# Access Compliance Report

## Public Rights-of-Way

### (Curb Ramps)

| Intersection ID: 31213 | Main Street: MANGLA_DR | Cross Street: MOUNTAIN_TRAIL_DR | Location: W            |

| ADA ID: 1E5A34B1B78C   | Ramp Type: PerpDiag    | Initial Pass/Fail: Fail         | Overall Compliance: No |

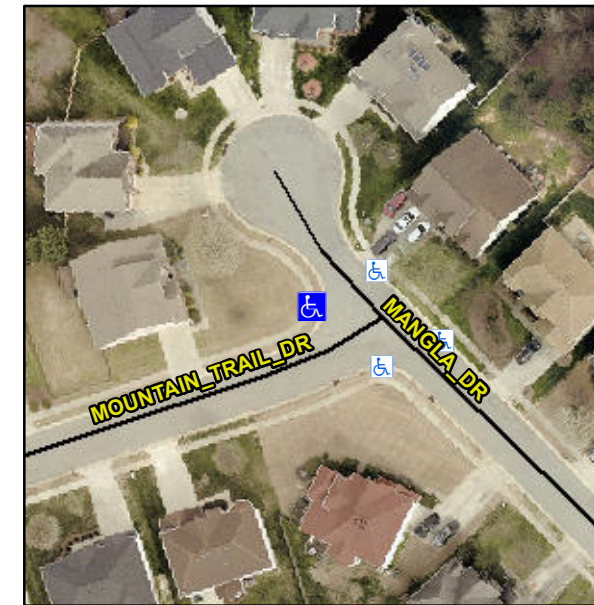
**Remove & Replace Curb Ramp With Two New Directional Ramps or Equivalent.**

**R304.5.1, R304.5.3**

| Compliance | Description           | Data  | Compliance | Description                 | Data |
|------------|-----------------------|-------|------------|-----------------------------|------|
| N/A        | Ramp Length (in)      | 53.0  | Yes        | Ramp Slope (%)              | 6.9  |
| No         | Ramp Width (in)       | 33.0  | No         | Ramp XSlope (%)             | 2.4  |
